**SITE DEVELOPMENT PLAN**  
**LOT 2 CLAREMONT BUSINESS PARK 2**  
**FILING NO. 2**  
**QUALITY BRAND GROUP CO., LLC**  
**PC# 364842**  
**EL PASO COUNTY, CO**

**LANDSCAPE NOTES & DETAILS**  
**L.O.O.**

**File number: PPR2345**

**VICINITY MAP**

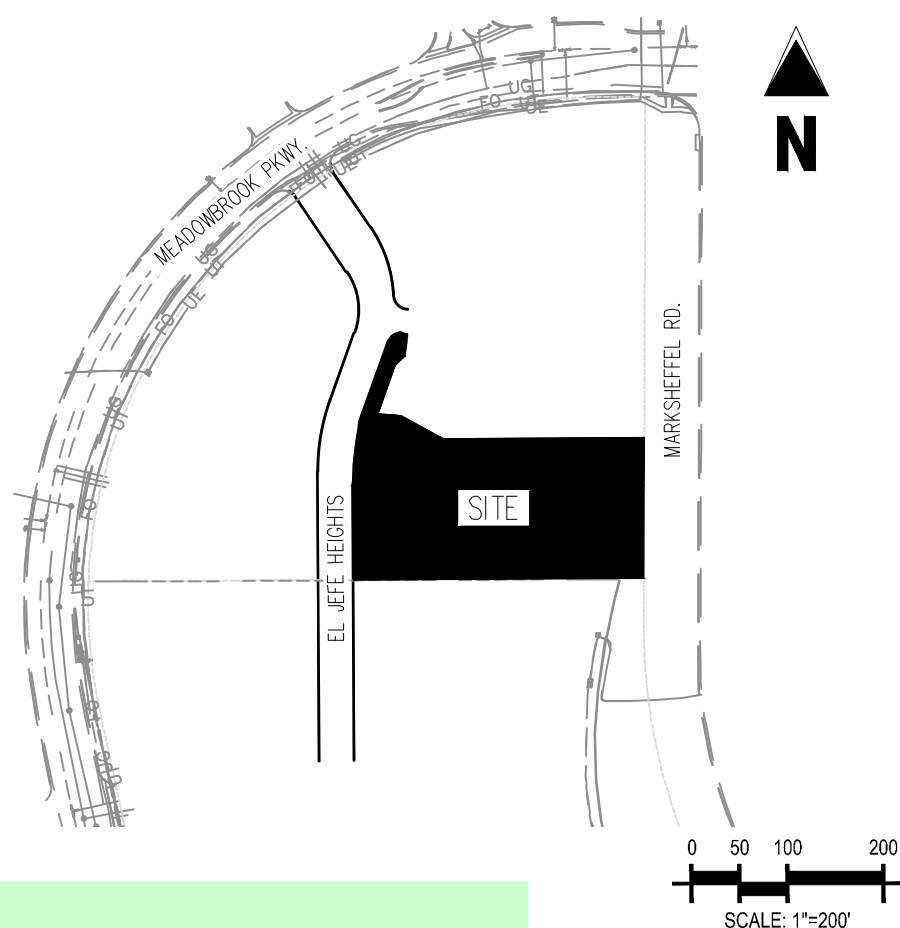
Please include:  
-property address  
-zoning  
-lot size  
-parcel number
